Access Compliance Report

Public Rights-of-Way

(Curb Ramps)

Intersection ID: N/A	Main Street: REA_RD	Cross Street: N/A	Location: NW
ADA ID: F36FE6C80694	Ramp Type: Perp	Initial Pass/Fail: Fail	Overall Compliance: No
		Severity Score: 60

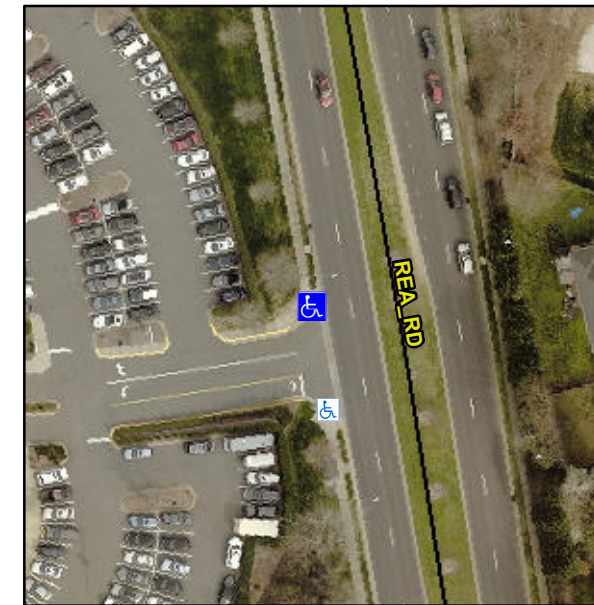
Not Found, R304.5.1, R304.5.3

Compliance	Description	Data	Compliance	Description	Data
N/A	Ramp Length (in)	99.5	Yes	Ramp Slope (%)	7.0
No	Ramp Width (in)	28.5	No	Ramp XSlope (%)	8.0
N/A	Flare Type LT	N/A	N/A	Flare Type RT	N/A
N/A	Flare Slope LT (%)	N/A	N/A	Flare Slope RT (%)	N/A
N/A	Flare Traversable LT?	N/A	N/A	Flare Traversable RT?	N/A
N/A	Landing Length (in)	N/A	N/A	DWS Provided?	N/A
N/A	Landing Width (in)	N/A	N/A	DWS Contrast?	N/A
N/A	Landing Slope (%)	N/A	N/A	DWS Length (in)	N/A
N/A	Landing X Slope (%)	N/A	N/A	DWS Full Width?	N/A
N/A	Landing Curb? (Y/N)	N/A	N/A	DWS Offset (in)	N/A
N/A	Shared Landing?	N/A			
N/A	Gutter Ponding?	N/A	N/A	Gutter Slope (%)	N/A
N/A	Gutter Lip Ht (in)	N/A	N/A	Gutter X Slope (%)	N/A
N/A	Painted X Walk1?	No	N/A	Painted X Walk2?	N/A
	X Walk 1 Direction	To S		X Walk 2 Direction	N/A
N/A	X Walk 1 Width (in)	N/A	N/A	X Walk 2 Width (in)	N/A
	X Walk 1 Slope (%)	3.3		X Walk 2 Slope (%)	N/A
	X Walk 1 X Slope (%)	6.5		X Walk 2 X Slope (%)	N/A

Remove & Replace Entire Ramp.
